Attachment C to
Comments of AGA, et al.
Docket No. EERE-2017-BT-STD-0019
RIN 1904-AD91
Filed May 16, 2022

Comments of AHRI

Re: Proposed Rule Energy Conservation Standards for Residential Furnaces;
Docket Number EERE-2014-BT-STD-0031

Figure 13: DOE Assumed Consumer Discount Rates

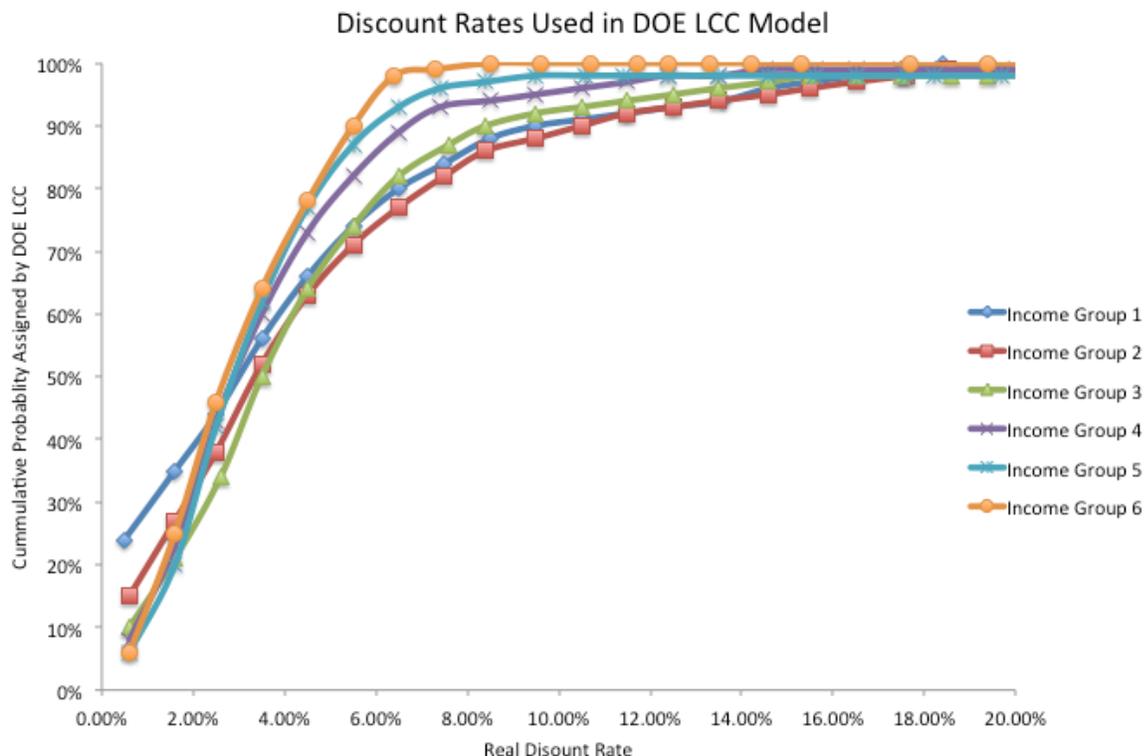
In this context, the DOE assumed real discount rates appear to be improbable representations of the actual financial situations faced by consumers. In its LCC, DOE has average discount rates of (Figure 13):⁵⁹

- Income Group 1 (0-20th Percentile) – 4.9%
- Income Group 2 (20-40th Percentile) – 5.1%
- Income Group 3 (40-60th Percentile) – 4.8%
- Income Group 4 (60-80th Percentile) – 4.0%
- Income Group 5 (80-90th Percentile) – 3.8%
- Income Group 6 (90-100th Percentile) – 3.6%

The true marginal discount rates for consumers are much more likely to cluster around 8-9% than around 3-5%. First, as demonstrated by both reasonable analysis of consumer balance sheets and the survey data, only a minority of consumers will be able to use cash or other savings in order to pay for a furnace replacement. Even then, cash is not a low/no cost source of funds since it must be replaced with high cost funds or deferred consumption in order to rebuild the liquidity cushion. The marginal source of funds for most consumers is credit card debt (estimated by DOE at 14.2-15.0% interest rate)⁶⁰. According to the American Housing Survey, only 7% of respondents had home equity loans or lines of credit (the lowest cost of borrowing for most consumers).⁶¹ (While home mortgages are also a low cost source of funds, the transaction costs and time for refinancing a mortgage make first mortgages an unlikely source of funds for a furnace replacement.) A small portion of households in Income Groups 5 and 6 may be able to finance a furnace replacement by drawing on non-retirement savings. However, these will also have a cost of funds estimated by DOE at 4.2% for debt to 9.2% for equities.⁶² While this may yield an average cost of consumer capital below 8-9%, it is unlikely that DOE wishes to justify standards on the ability of the upper 10% of consumers to finance them at relatively lower costs of capital.

Figure 14: DOE vs. Contractor Survey Furnace Installation Costs – North

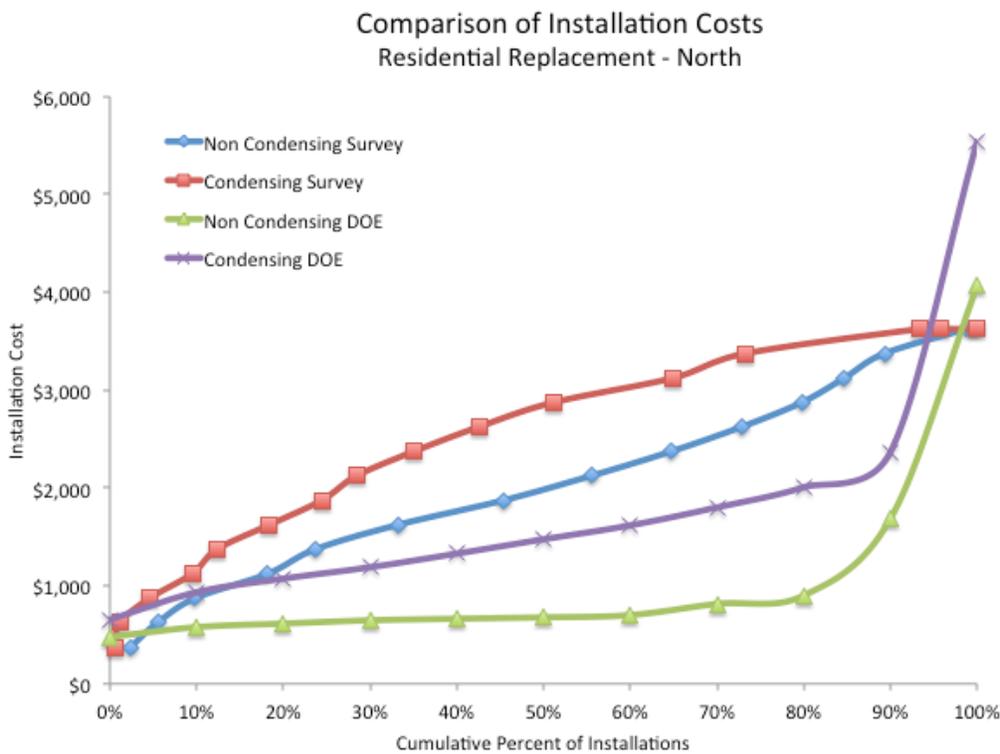
The total distribution of costs shows a consistent pattern of DOE underestimating the cost of installation (Figure 14 & Figure 15).

Figure 19: DOE Furnace TSD Figure 8C3.3

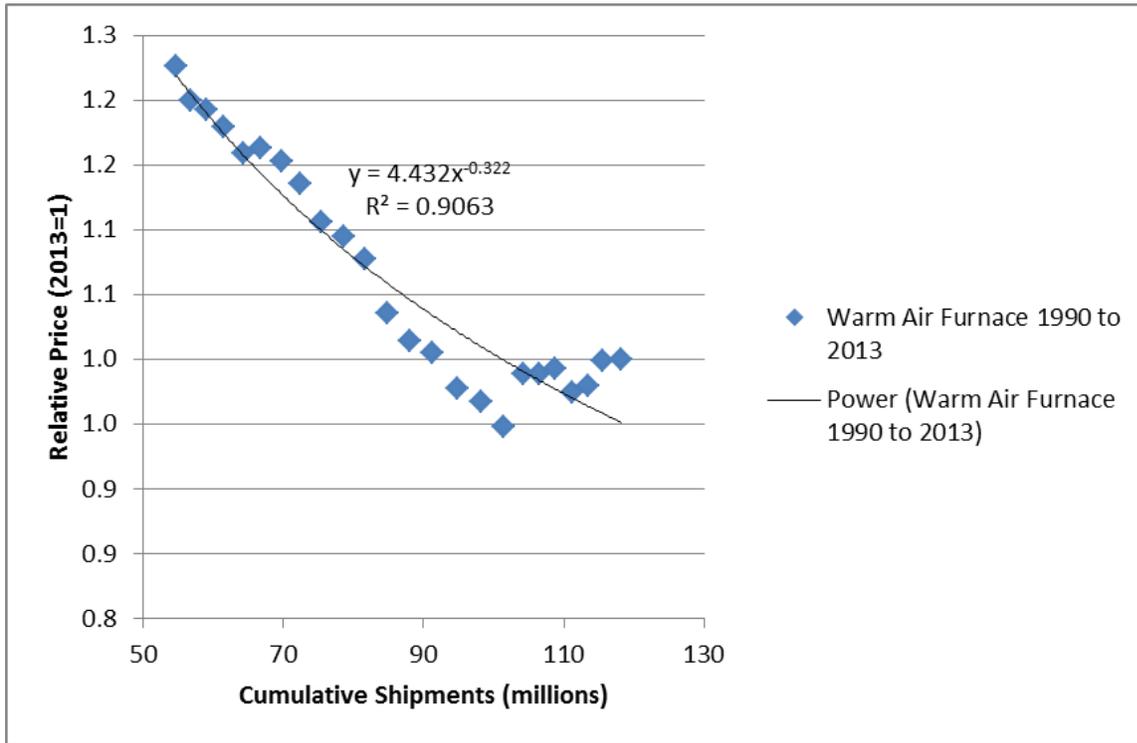
The importance of data and taking it as it comes can be seen through Figure 8C.3.3 in the Furnace TSD (Figure 19). It appears that there has been a structural change in the price/shipment relationship for the final seven data points. DOE chose to fit a single curve through all its data points rather than the more obvious solution of starting a separate curve for the final seven. Victor Franco, for DOE, stated: “we fit basically, we do the best fit to that curve.” By inspection (Figure 20), there would be a better fit by drawing two curves. One would go through the last seven data points and one would go through the others. However, this can only be inferred by inspection since DOE has not responded to AHRI’s request to release the actual numerical data behind the graphs.⁷¹

Figure 21: LCC Projected Fuel Use for 80 AFUE Furnaces

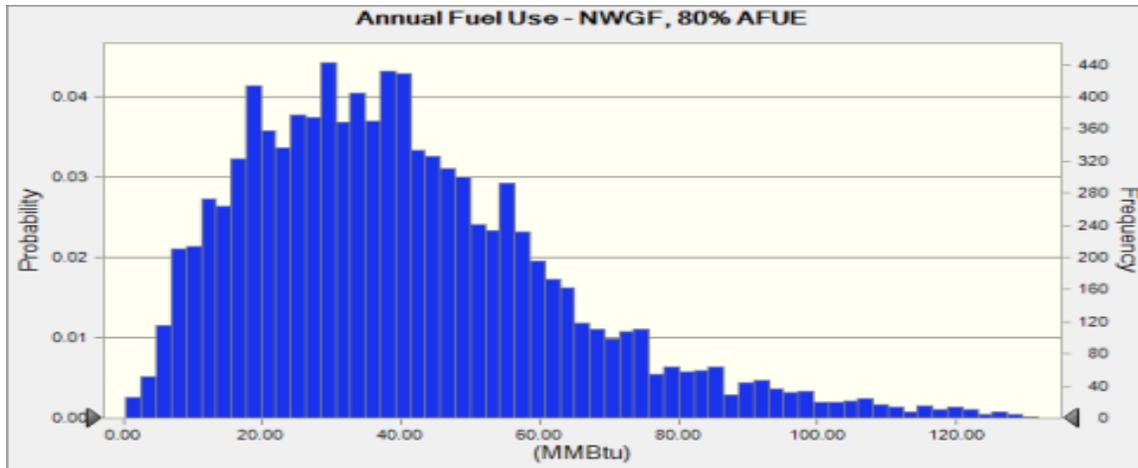
There is also something quite odd in the calculation of Annual Fuel Use. As can be seen from the graphs, the fuel use for 80 AFUE furnaces has a plausible distribution (Figure 21):⁸⁰

Figure 22: LCC Projected Fuel Use for 90 AFUE Furnaces

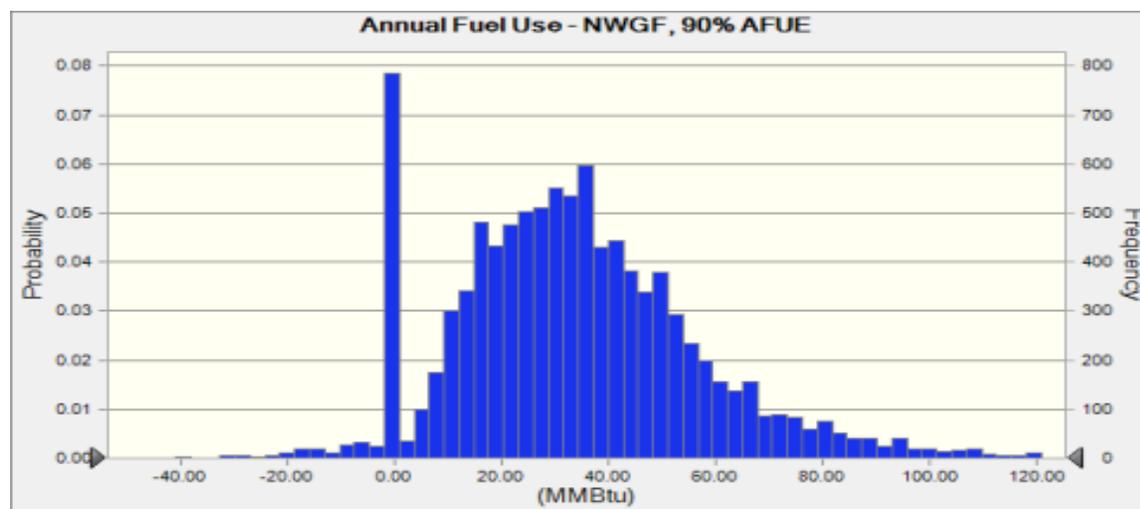
However, the fuel use for 90 AFUE furnaces has a very odd distribution (Figure 22):

Again, while it is not practical to debug the LCC model, the large value at zero fuel use and the negative values are highly unlikely to be real reflections of actual conditions. The negative fuel uses are unlikely to represent gas wells on peoples' properties. Something is significantly wrong with the DOE LCC model if it is projecting zero and/or negative fuel use.
